# DISPLAY THIS CARD ON PRINCIPAL FRONTAGE OF WORK CITY OF PORTLAND BUILDING PERMIT

has permission to <u>Change the Use to Brew pub & distillery w/interior renovations ADA ramp, NO REAR DECK APPROVED</u> provided that the person or persons, firm or corporation accepting this permit shall comply with all of the provisions of the Statues of Maine and of the Ordinances of the City of Portland regulating the construction, maintenance and use of the buildings and structures, and of the application on file in the department.

re: building permit application In'finiti Fermentation & Distillation 250 Commercial St Dept. of Building Inspections City of Portland Maine

A review has been conducted of the proposed layout/construction for a new brew pub, with a small distilling operation, which is to be located within a newly renovated space on the 1<sup>st</sup> floor of a commercial building at 250 Commercial Street in Portland, ME. The purpose of this review was to evaluate the proposed inclusion of a small distillery operation within the brew pub, including the potential fire/explosion hazards that may exist and assess the need to provide adequate fire separation of this operation from the

2 FLOOR PLAN - PHASE 2 DECK ADDITION 5CALE: 1/8"=1'-Ø"

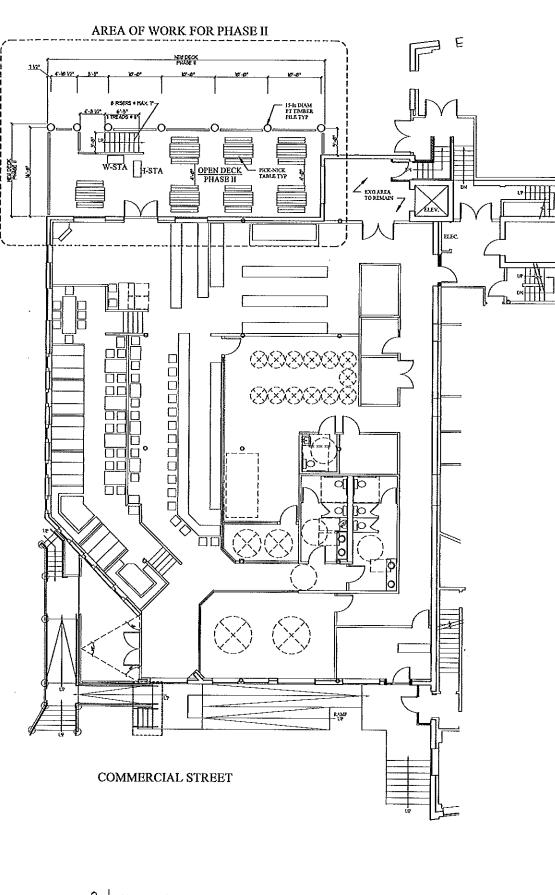
Yes, as long as it is completely clear that the present permit application does not include the deck.

I am doing the zoning review for this permit. I understand that you would like to move the permit forward without the rear deck. Could you submit revised plans that do not show the deck. If there are going to be

temporary steps for egress from the existing loading dock please indicate those on the plan.

>>> Jared McKenna <jared@archetypepa.com> 5/23/2012 2:37 PM >>> Attached are new plans to show the ramp and stairs to be included in this permit. The footprint of both will total less than 500 sq ft of additional square footage to the existing footprint.

You'll note the that deck will now be another phase and we will be applying for a Level II Site Plan Review in the future for this.

It would be better for us to show the deck as phase 2 and have a temporary stair detail added for egress. Can we resubmit like this?
